Subject: Supplemental Information to WCAP-17524, "AP1000 Core Reference Report" to Address Thermal Conductivity Degradation (Proprietary/Non-Proprietary)

Subject: Westinghouse Response to NRC RAIs on WCAP-17524, "AP1000 Core Reference Report"
(Proprietary/Non-Proprietary).

**Westinghouse Response to NRC RAIs on WCAP-17524, “AP1000 Core Reference Report”
(Non-Proprietary)**

Figure 1: Comparison of equivalent rod ejection problem results between ANC and SPNOVA

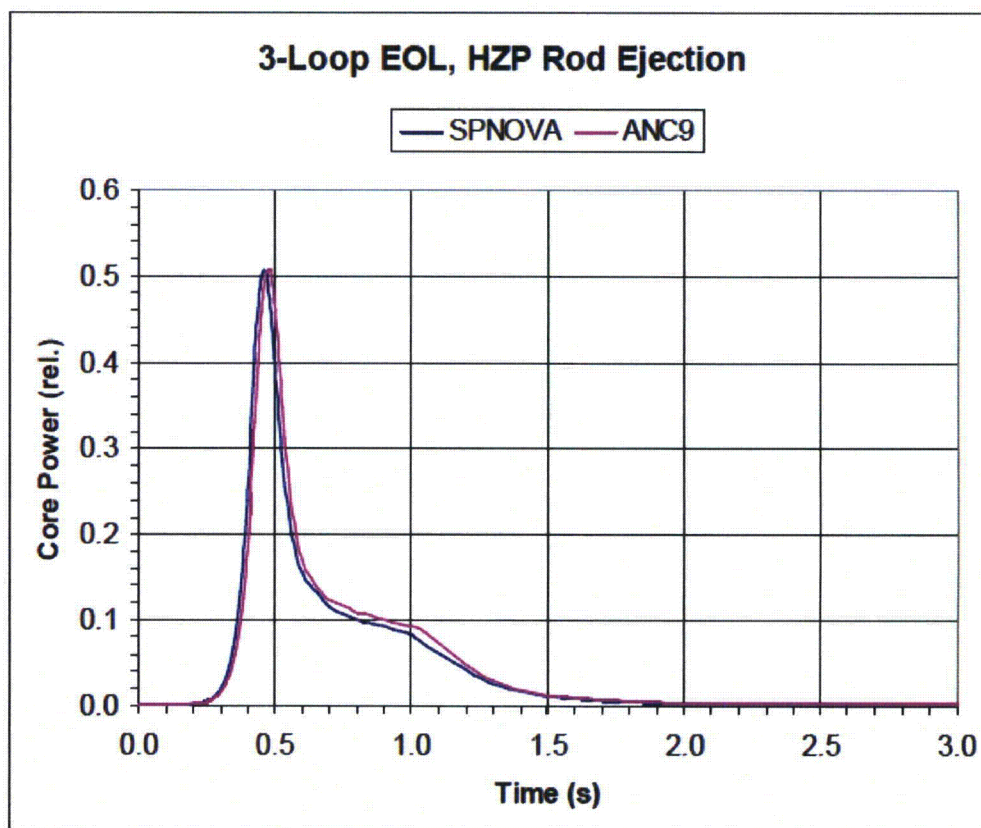
To ensure that the results of the kinetics implementation in ANC version 9.3.0 provides results consistent with previous 3D Rod Ejection analyses using the SPNOVA code, a qualification study was performed to benchmark the results of ANC version 9.3.0 to SPNOVA. This study was performed on a typical 3-loop core (i.e., corresponding to that used in the original 3D Rod Ejection topical report - WCAP-15806-P-A, Reference 1), however, the implementation of the space-time kinetics capability is independent of core size or arrangement. Thus, these results are representative of SPNOVA vs. ANC 9.4.0 performance for an AP1000® Pressurized Water Reactor (PWR). When the SPNOVA and ANC problems were run with consistent core models, for consistent ejected rod worth, and with a consistent thermal feedback model, the core power transient as generated by the two codes was demonstrated to be nearly identical, as shown in the figure below:

Overall, the qualification testing of the multi-dimensional kinetics implementation demonstrated that ANC version 9.3.0 and SPNOVA give equivalent results for a representative rod ejection transient.

Figure 2: Hot Rod Axial Power Shape Comparison for CRR Run087

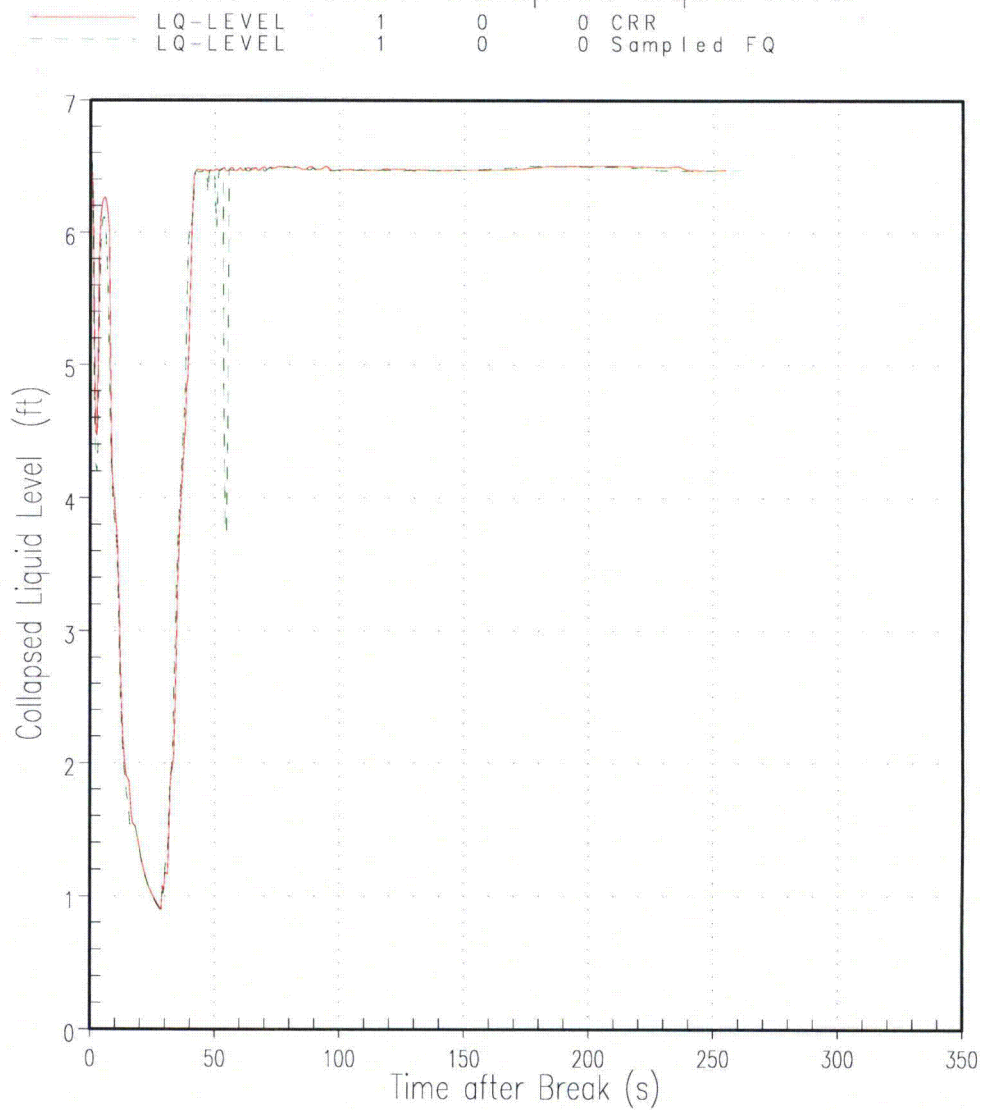
The PBOT, PMID modifications for the top two CRR analysis cases are summarized in Table 1. The original CRR and revised axial power shapes are shown in Figure 1 and Figure 2 for run031 and run087, respectively. The as-sampled FQ values and the as-executed FQ values for these runs in the CRR and the margin cases are summarized in Table 2. Similarly, the desired PLHR and as-executed PLHR values for these runs are summarized in Table 3. The PBOT/PMID space with the original sampled points for all 124 runs and the modified points for the top 2 cases are shown in Figure 3. The revised axial power shapes meet the criteria specified above.

Figure 4: AP1000 CRR Run031 Impact of Axial Power Shape Change: Lower Plenum Collapsed Liquid Level

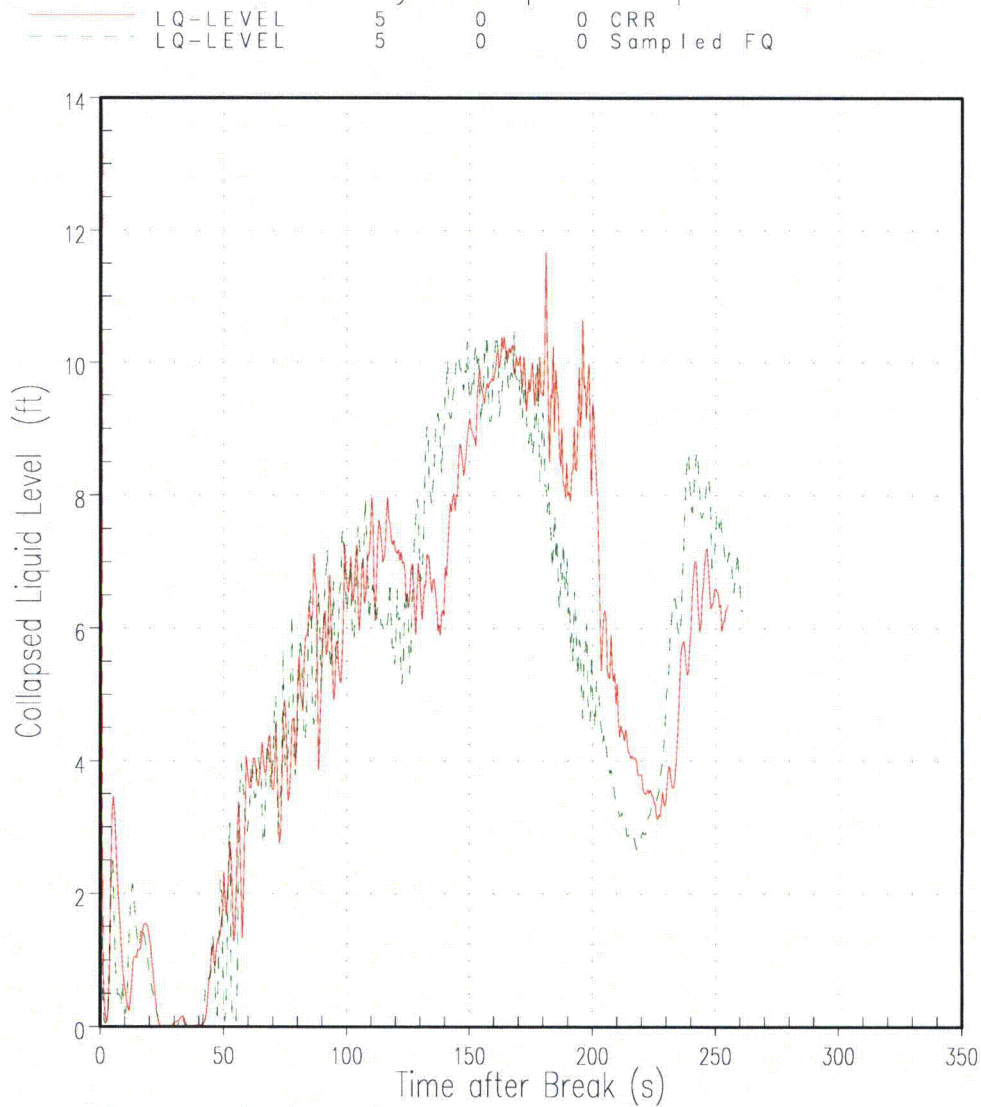
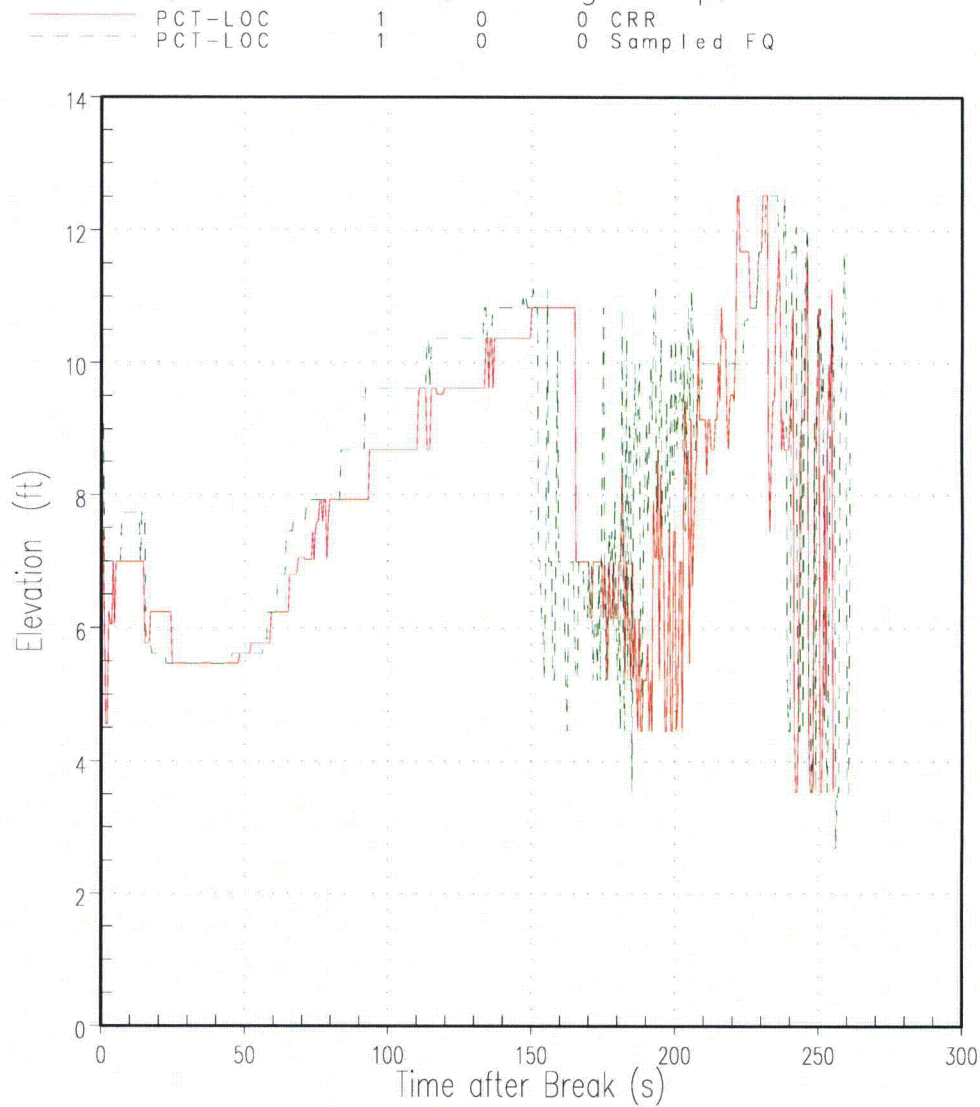
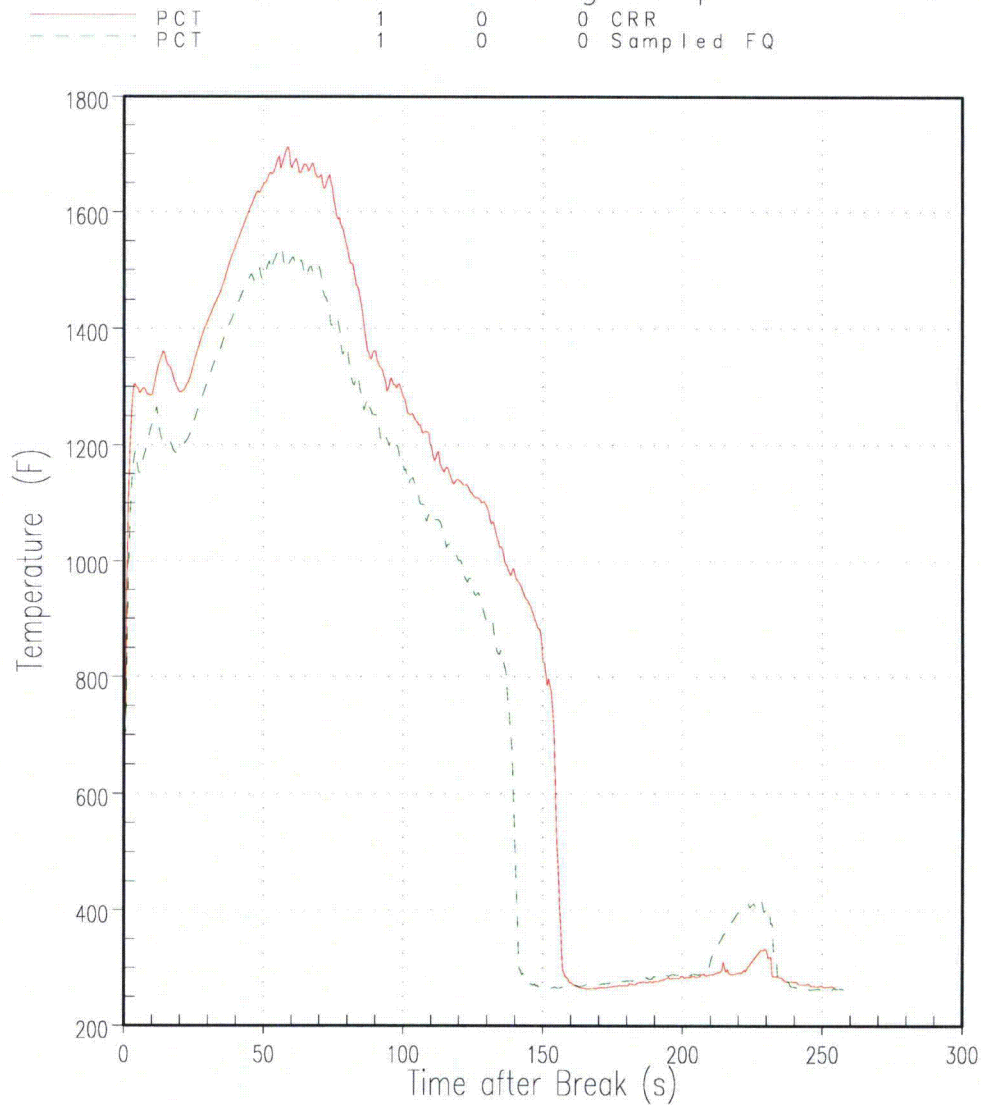
Selected plots for run031 with the original CRR analysis axial power shape and with the modified axial power shape are shown in Figure 4 through Figure 7. [

Figure 15.6.5.4A-1

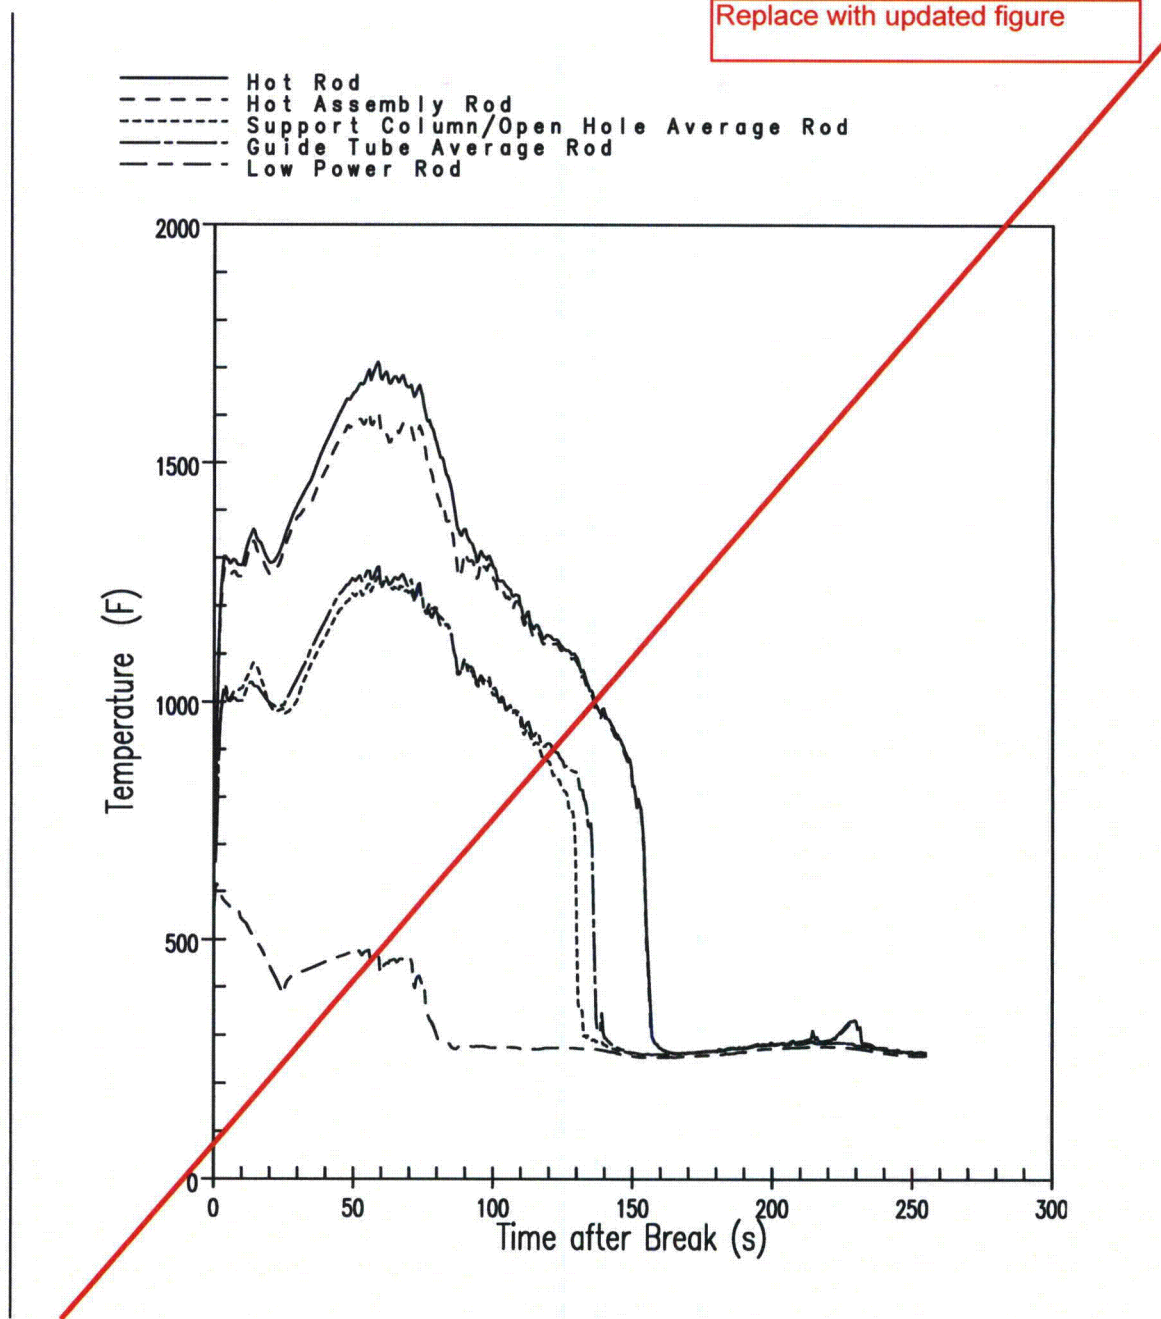
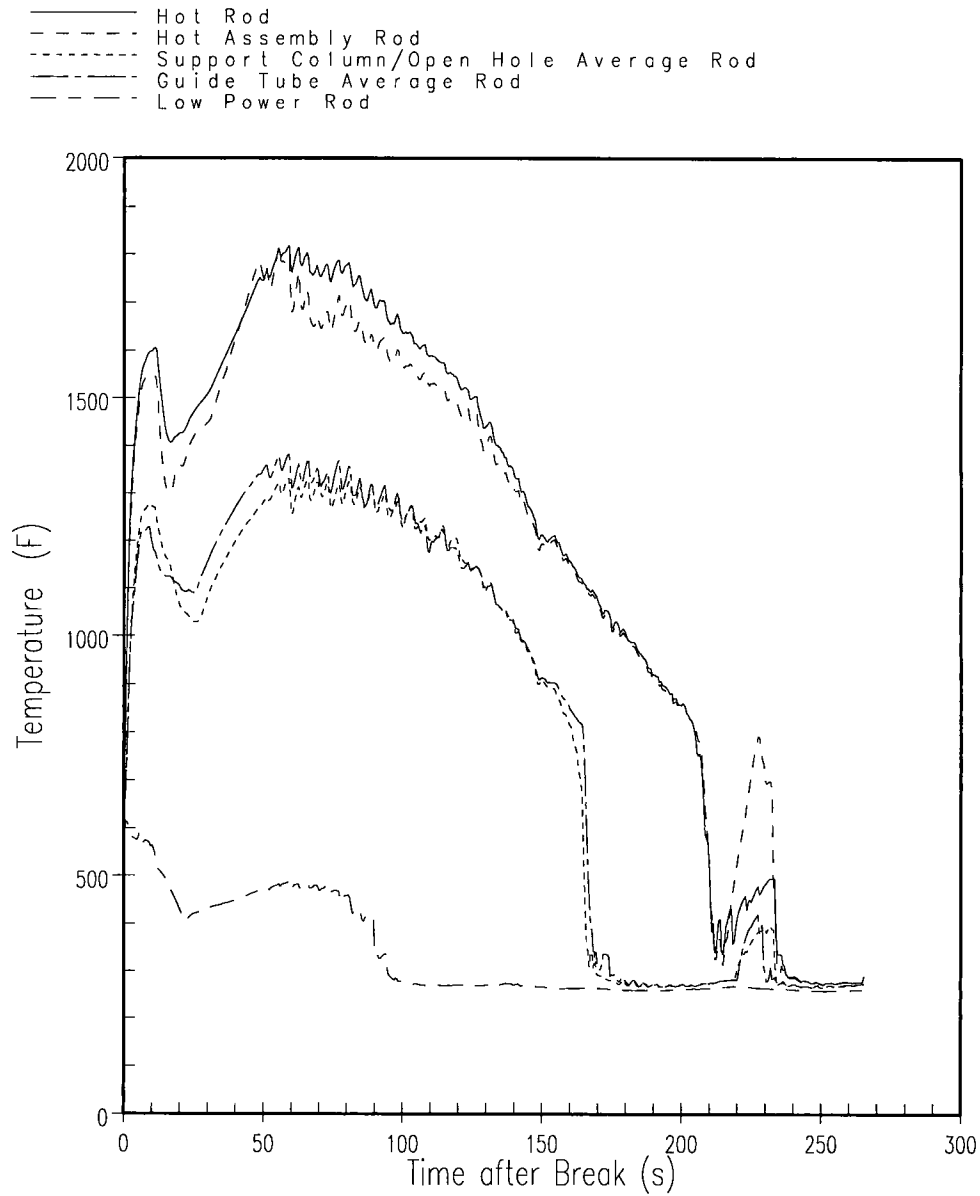
In Figure 15.6.5.4A-1, “Hot Rod” refers to the hot fuel rod at the maximum linear heat rate for the run, “Hot Assembly” refers to; the average fuel rod in the hot assembly that contains the hot rod, “Support Column/Open Hole” refers to the fuel rod in average assemblies under support columns or open holes, “Guide Tubes” refers to the fuel rod in average assemblies under guide tubes, and “Low Power” refers to the fuel rod in the low power peripheral fuel assemblies.

The timing of the initial downflow into the hot assembly is similar to that of the downflow into the open hole/support column average assemblies. By 11 seconds into the transient, liquid that has built up in the global region above the hot assembly begins to flow into the hot assembly (Figure 15.6.5.4A-3). Significant flow of continuous liquid into the hot assembly exists between 11 to 22 seconds. The liquid flow is not enough to quench the hot rod and hot assembly rod or the average rods at all elevations (Figure 15.6.5.4A-1) although some cooling is achieved.
